Upgrade kit

Upgrade Kit B5530 for Soft shift valve – SWP 4 MW Power pack

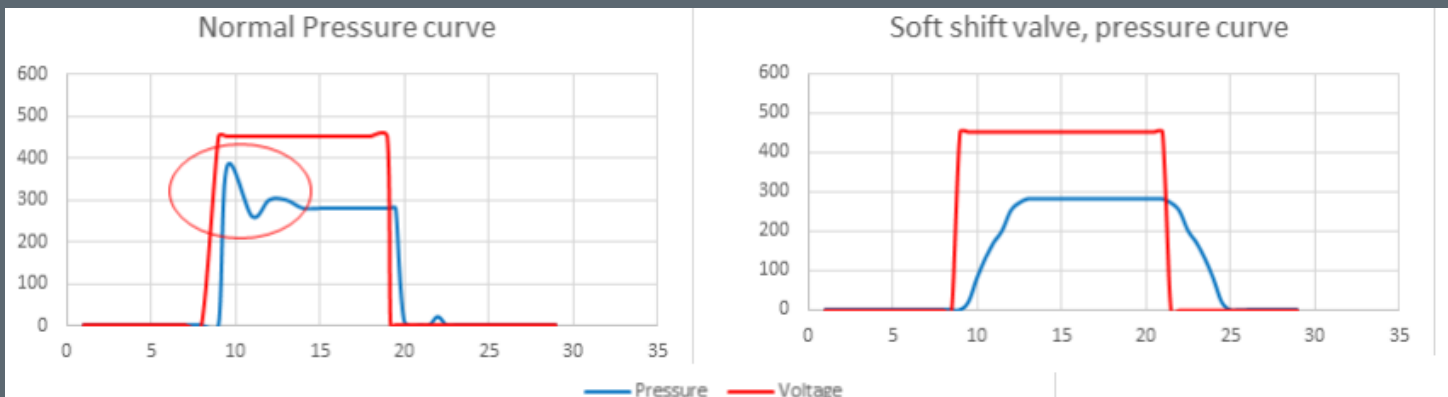
Some of our customers have experienced burst hydraulic hoses and fatigue of the manifold due to pressure peaks in the system. The **SOFT SHIFT VALVE** prevents these pressure peaks as seen on the graphs.

Installing the soft shift valve from Dellner Hydratech gives following advantages

- Slow pressure increase
- Slow flow increase
- Reduced pressure shock
- Reduced stress
- Lower water content in the oil
- Prevents cracked heat exchanger
- Prevents fatigue of the manifold
